Access Compliance Report

Public Rights-of-Way

(Curb Ramps)

Intersection ID: 52289	Main Street: DIXIE_RIVER_RD	Cross Street: GANNON_DR	Location: S
ADA ID: 6AB8A278FF38	Ramp Type: Perp	Initial Pass/Fail: Pass	Overall Compliance: No
			Severity Score: 0.25

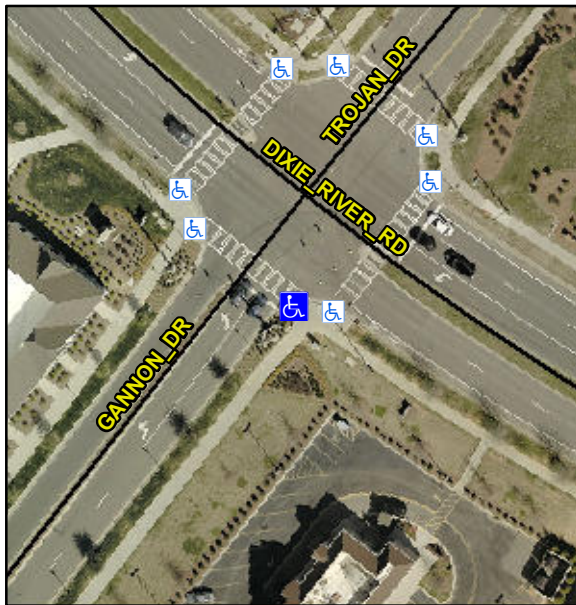
**Not Found, R304.5.3, R304.2.1,
R304.2.2-Perp, R304.3.2-Para**

Compliance	Description	Data	Compliance	Description	Data
N/A	Ramp Length (in)	98.0	Yes	Ramp Slope (%)	5.6
Yes	Ramp Width (in)	48.0	No	Ramp XSlope (%)	3.1
N/A	Flare Type LT	Sloped	N/A	Flare Type RT	N/A
N/A	Flare Slope LT (%)	8.0	Yes	Flare Slope RT (%)	1.6
N/A	Flare Traversable LT?	Yes	N/A	Flare Traversable RT?	Yes
Yes	Landing Length (in)	90.0	Yes	DWS Provided?	Yes
No	Landing Width (in)	47.5	Yes	DWS Contrast?	Yes
No	Landing Slope (%)	3.0	Yes	DWS Length (in)	24.0
Yes	Landing X Slope (%)	2.7	Yes	DWS Full Width?	Yes
N/A	Landing Curb? (Y/N)	No	Yes	DWS Offset (in)	0.0
N/A	Shared Landing?	No			
Yes	Gutter Ponding?	No	Yes	Gutter Slope (%)	1.5
Yes	Gutter Lip Ht (in)	0.0	No	Gutter X Slope (%)	3.2
N/A	Painted X Walk1?	Yes	N/A	Painted X Walk2?	N/A
	X Walk 1 Direction	To NW		X Walk 2 Direction	N/A
N/A	X Walk 1 Width (in)	116.0	N/A	X Walk 2 Width (in)	N/A
	X Walk 1 Slope (%)	2.5		X Walk 2 Slope (%)	N/A
	X Walk 1 X Slope (%)	2.8		X Walk 2 X Slope (%)	N/A

**Remove & Replace Entire Ramp.
Remove & Replace Gutter.**
